San Mateo County Board of Supervisor's Meeting

File Numbers: **PLN 2005-00603**

Subject: Revised Letter of Decision - File Number PLN2005-00603
Location: 21 Estrada Place, Palomar Park
APN: 051-022-420

Re: San Mateo County Planning Commission Meeting No. 1491 Item 6: 25 Estrada Place, Palomar Park;
PLN 2005-00603 -- APN 051-022-420

Approved hillside grading – 16 foot cut – to create level pad

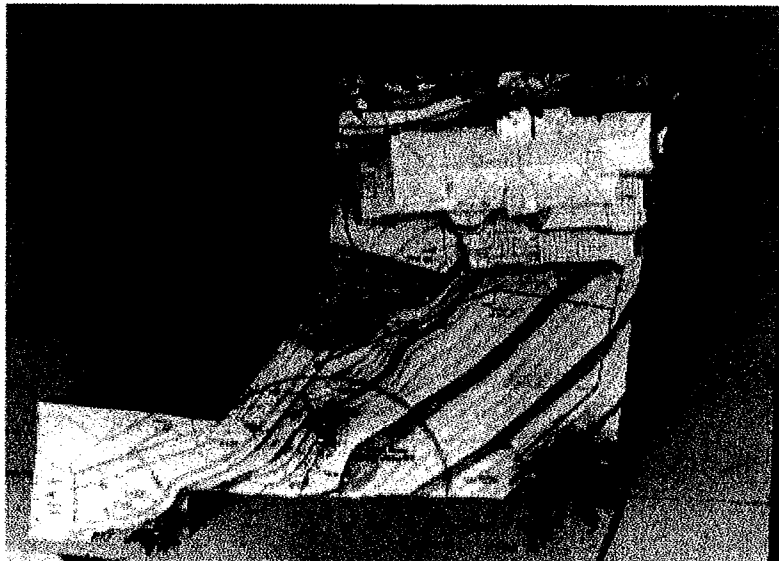
- This 6000 sq ft house is sited on topography which is cross-sloped, and yet it features a 3000 sq ft *level pad* resulting in extensive grading and cutting (16.5' vertical cuts) into a 30% slope, despite there being ~1900 sq ft of level, treeless space which is being used for the driveway.

Base drawings from Applicants May '06 and June '07 plans

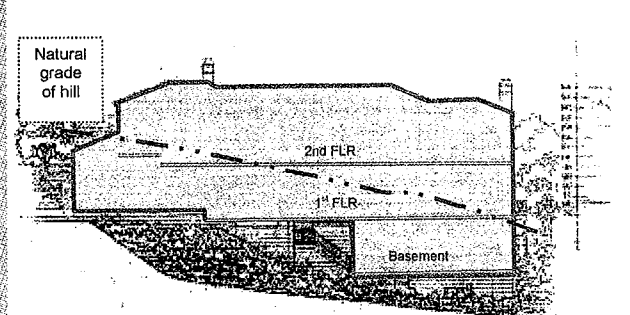
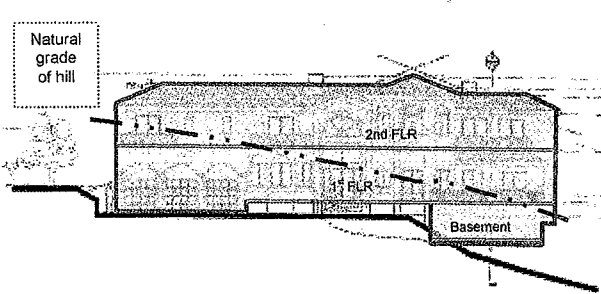
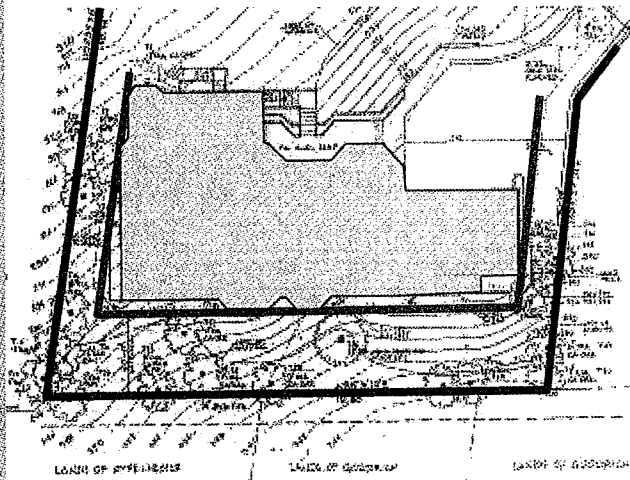
- Comparison of the footprint and profile of the original design rejected in May 2006 with the current design. It is virtually unchanged.
- The approved design is the 4th revision and shows an increase in total square footage of 139 sq ft from the first plans submitted. The footprint of the structure has grown.
- From the contour line of the natural grade [dashed red line- lower pair of drawings], it is clear that no attempt has been made to step the structure with the hillside.
- To create the pad for the structure the natural grade is being cut from the dashed red line to the first floor level grade.

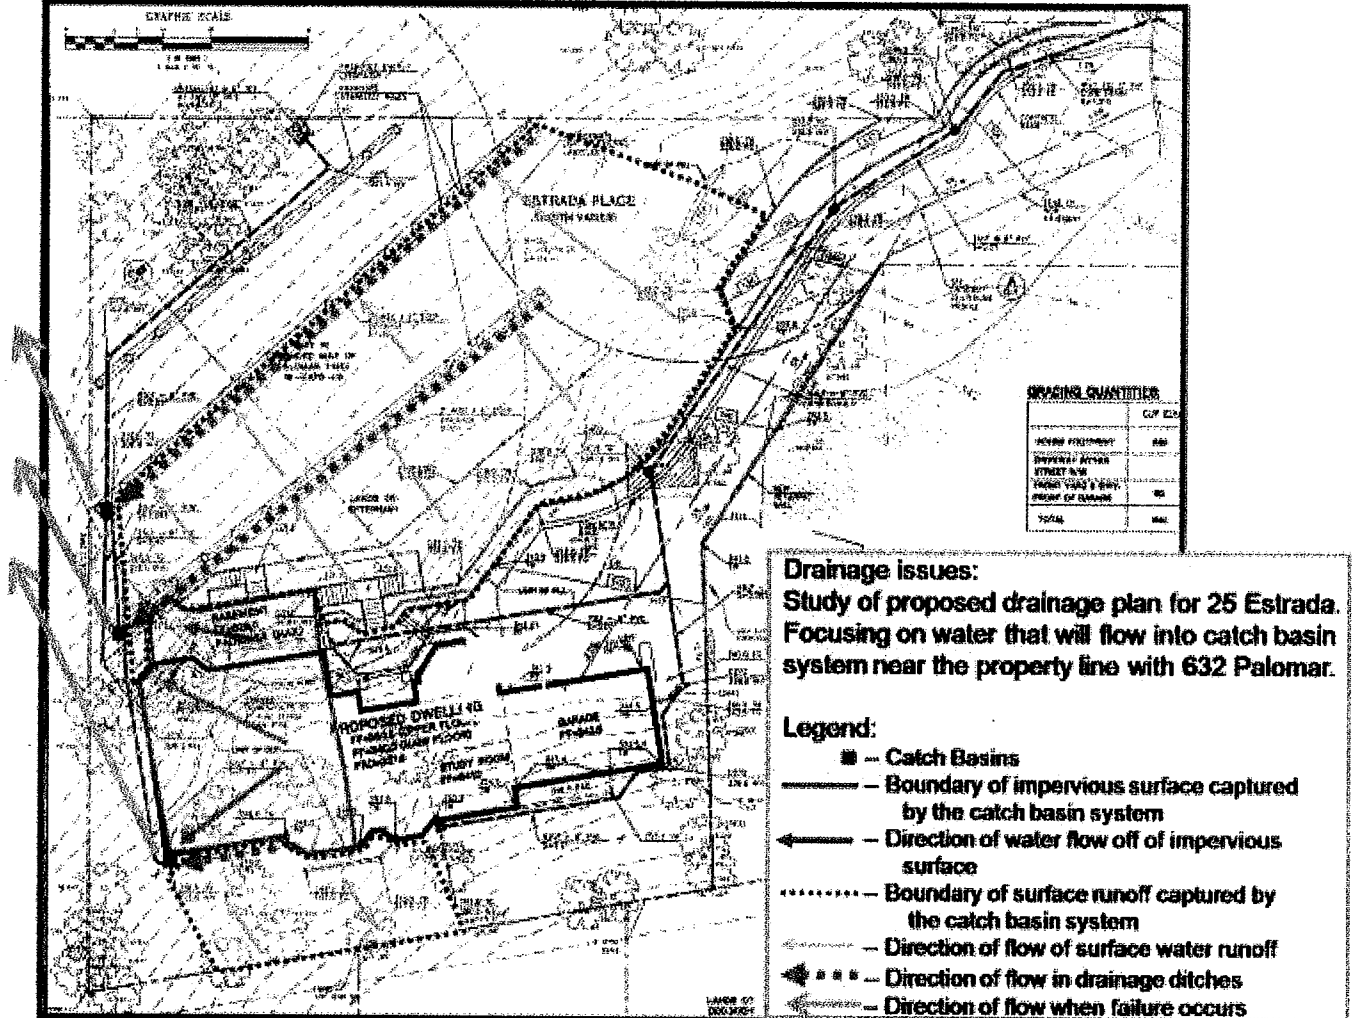
I am concerned with the revised drainage plans for the site regarding water directed toward the western property line. Each of the three catch basins (green dots -see diagram below) is fed by a 2' wide x 6" deep drainage ditch (dash red lines) collecting surface run off and run off from impervious surfaces on the western half of the structure.

Any significant amount of rain will cause the drainage ditches to direct both water and debris to the catch basins. In the best case the debris will flow through the grate of the basin; in the worst case the debris will clog the grate or plug the 6 inch drainage line. This is based on our experience of living in the Palomar hills for 25+ years and maintaining the 8 inch drainage system on our own property which clogs regularly with twigs and leaves.

Example of trenching requirements

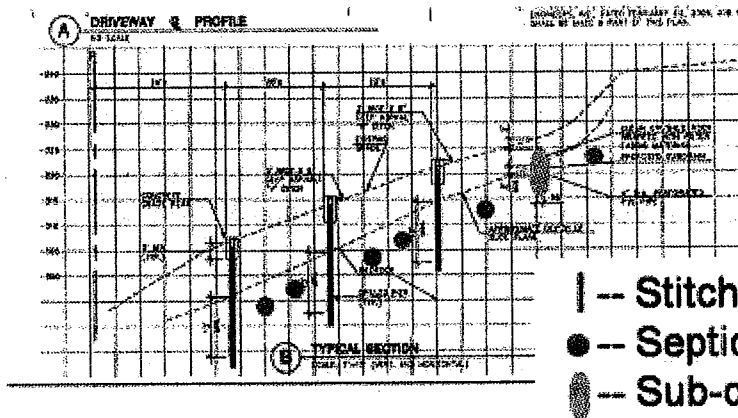
- Septic lines need to be placed 2-3' into competent soil below slide debris
- Septic lines are installed with a gentle slope of 1/4" per linear foot

In this example a 12' deep trench will need to be dug, removing

- 10' of debris and 2' of competent soil in the middle of the slope face
- 0' of debris and 12' of competent soil on either side of the slope face

Drawing C1 with approximate placement of septic lines from Romig Figure 7 March 2008

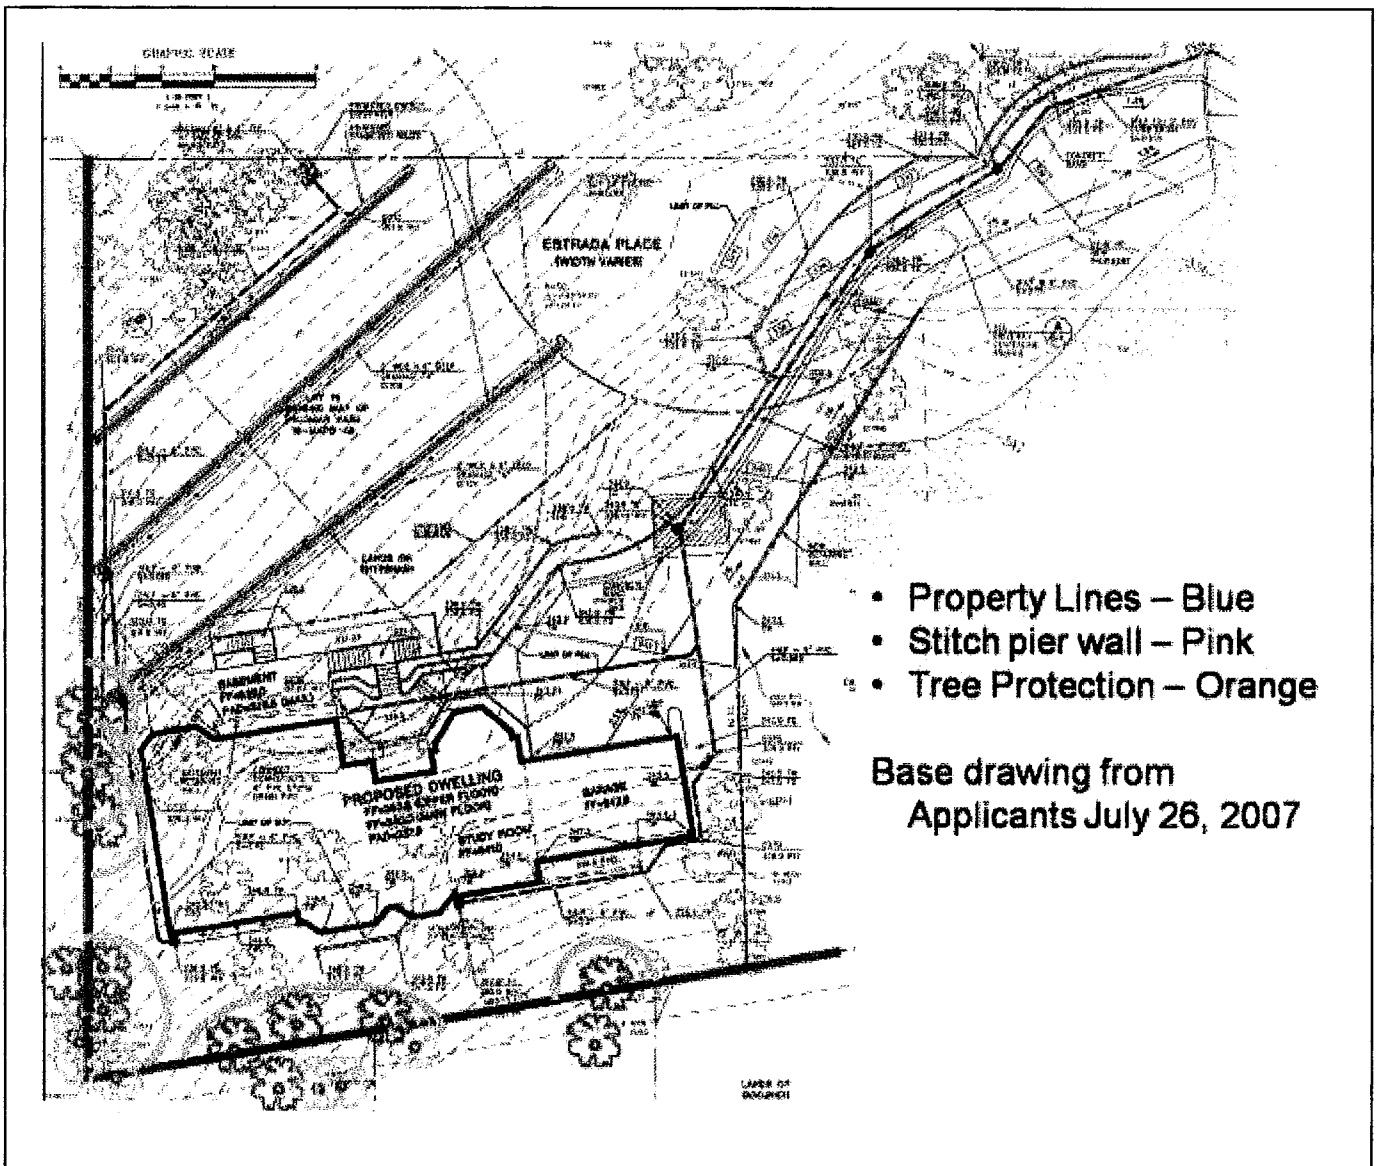
- A composite leach field schematic combining "figure 7 from Romig's March 2008 report" and "MacLeod drawing C-1 7-26-08" are shown in the "Approximate placement of septic lines" below. When viewed as a composite schematic the most uphill positioned leach line is to be placed uphill of a sub-drain. This sub-drain is to be placed in competent soil per Romig's report.
 - o This raises concerns of seepage of septic water into the drain runoff.

- Furthermore, the original septic plan that was submitted in 2006 showed septic lines placed on county property. When I brought this to the attention of Stan Low and the county planner, they looked at the plans and noted that an extra line could be installed.
 - o To my knowledge, the applicants' Environmental engineer has never validated a revised septic plan incorporating this solution. Nor has the septic plan been reviewed in context with the new geotechnical report and formally submitted to the county for review and approval.

Request: A combined slide stabilization plan, drainage plan, and septic system plan be submitted by the applicant and approved by the appropriate planning department before any further approval or permits are issued. This needs to be done since the original sub-division to create this lot was contingent upon proof that a leach field could be installed on this lot.

FIGURE 1 – Septic lines placed in landslide deposits

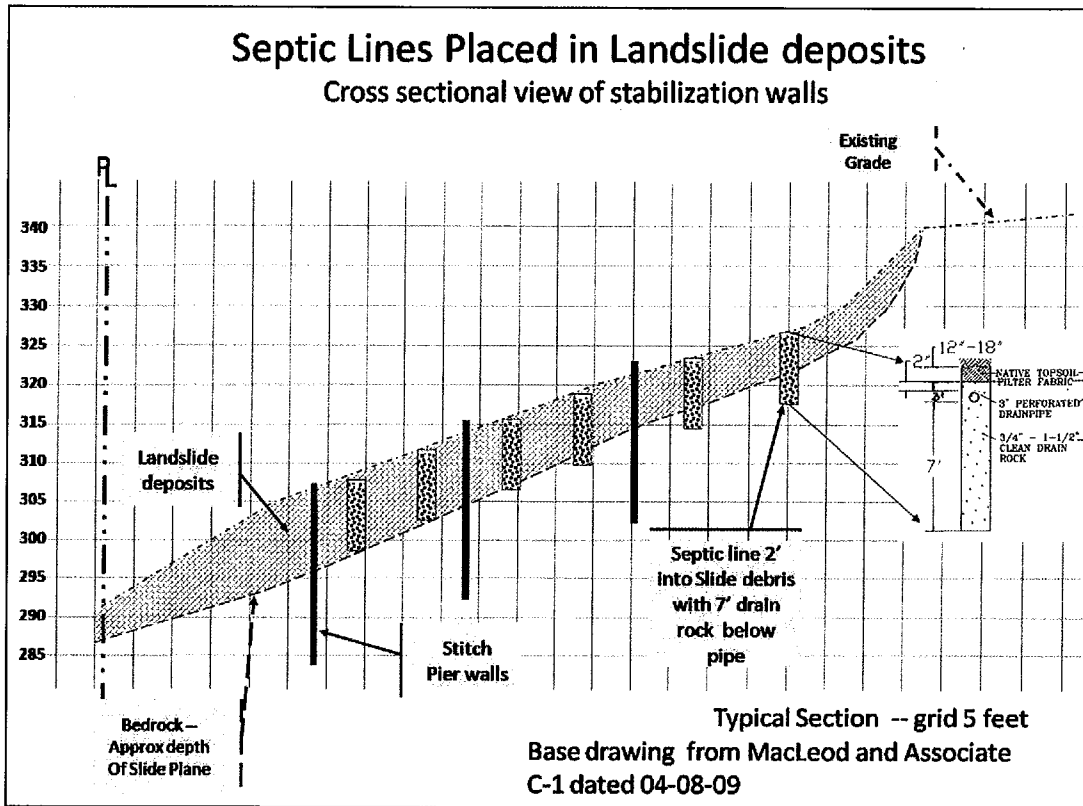
3. If the leach field is allowed to be placed in landslide debris (Figure 1) please address the following:
 - i. ***What were the reasons for allowing an exception to County policy, given the leach field is directly above a stream that flows to the Bay?***

FIGURE 2 – Septic lines placed below landslide deposits

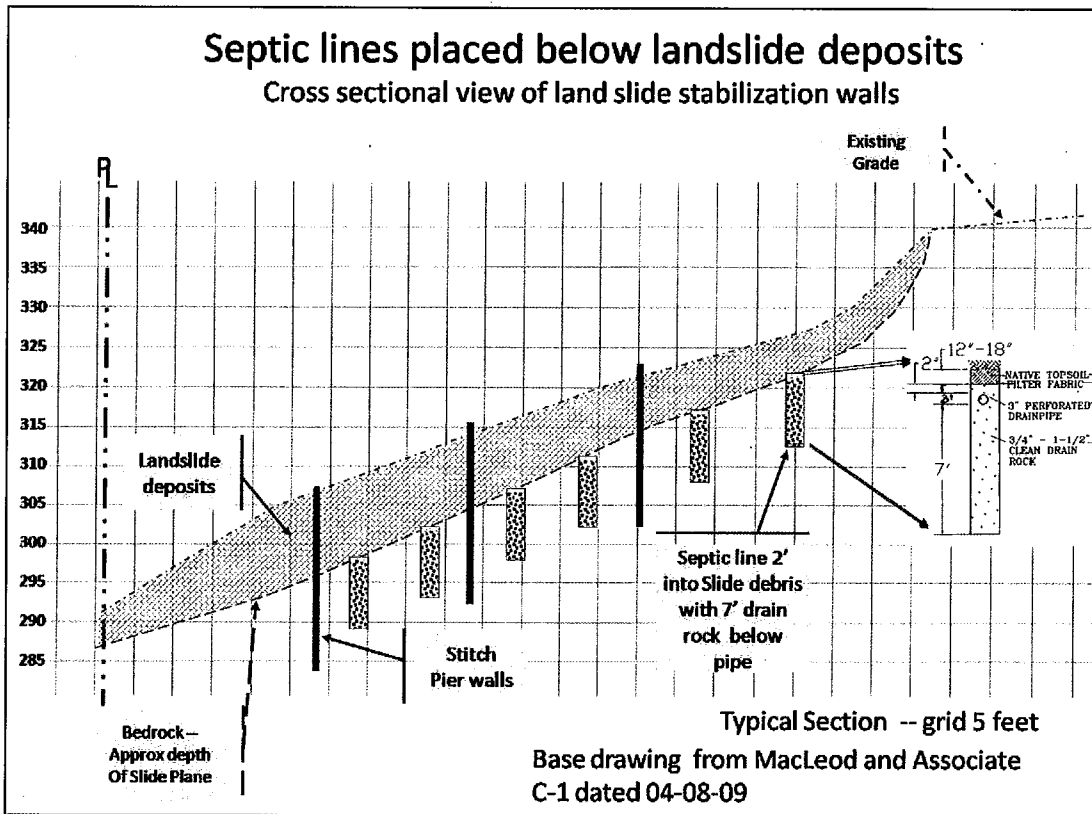
4. If the leach field needs to be placed in competent soil below the landslide debris (Figure 2) in accordance with County policy, please address the following:

FIGURE 3 - Depth of Septic Lines

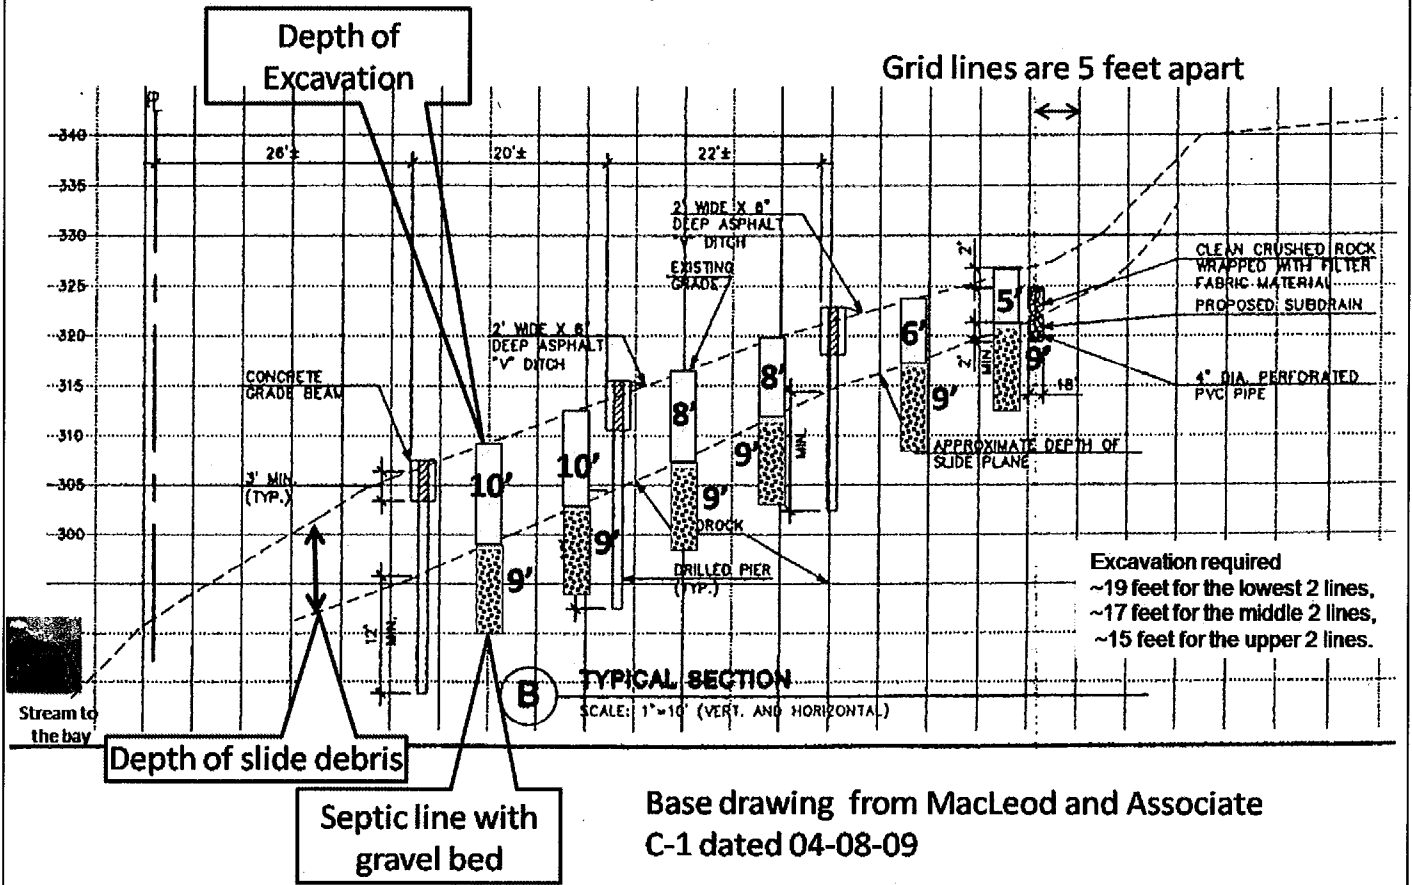
- Based on the Romig report and MacLeod C-1 drawing, there is between 5 to 10 feet of landslide debris above the slide plane. (Figure 3)
 - a. ***Digging down 14' to 19' through loose slide debris to place the drainage rock is not trenching. Won't this cause the installation of the leach field to become a major excavation task?***

- b. ***Is there any impact to the stitch pier wall with digging to these depths near the piers? (Figure 3)***
 - c. ***The exact depth of the slide debris is not known across the entire slope face for the length of each septic line. Doesn't this mean that for each of the septic lines, excavation for the entire length of the line must be done before any installation of the septic line or backfilling occur? (Figure 4)***

Figure 6 – Example of excavation and shoring

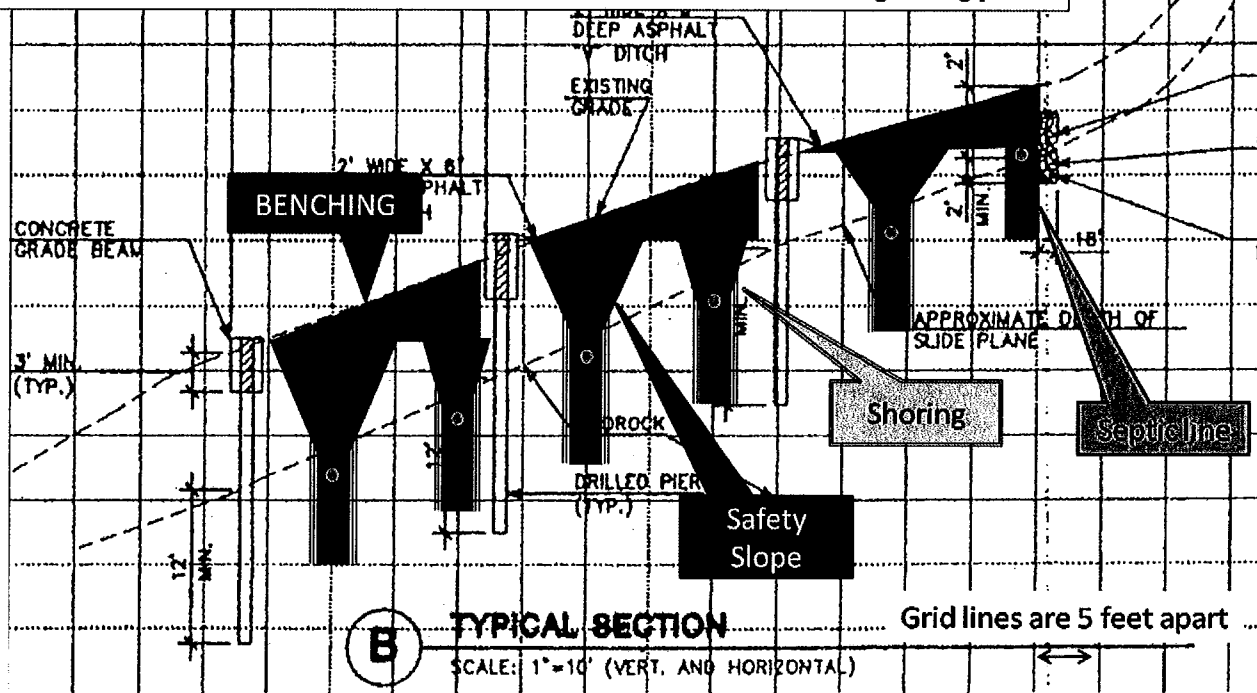
- ii. OSHA Regulations for "Sloping and Benching – 1926 Subpart P App B" deals with how to safely dig to these depths in different soil conditions. If you apply these regulations using a slope face ditch design, you are left with a top opening that is 38 feet wide; however, the distance between stitch piers is only ~20 feet. (Figure 5) Therefore, some combination for shoring and side sloping must be used to comply with this OSHA requirement. Benching will not eliminate this safety issue as the septic line furthest down the slope will still require ~17 feet of excavation. (Figure 6)

All blue areas will need to be cut and filled and is not included in grading plan!

FIGURE 7 – 22 degree slope

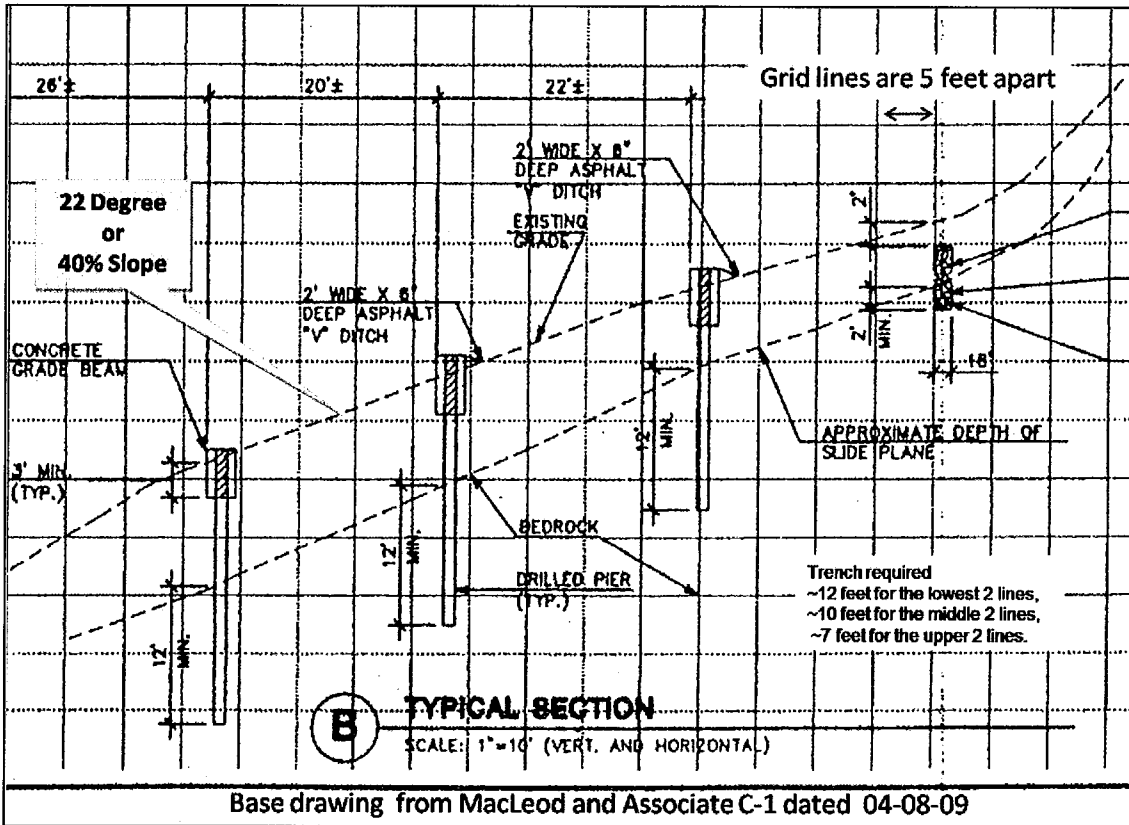
5. Construction of both the stitch pier walls and septic system will take place on a slope of 22 degrees (Figure 7). The safety literature of Caterpillar and Bobcat state that the maximum slope upon which their backhoe's and track excavators can operate are 25 degrees up/down a slope, but only 15 degrees across a slope. While operating on a 15 degree slope, the operator is directed to use extreme caution while lifting and swinging the bucket.
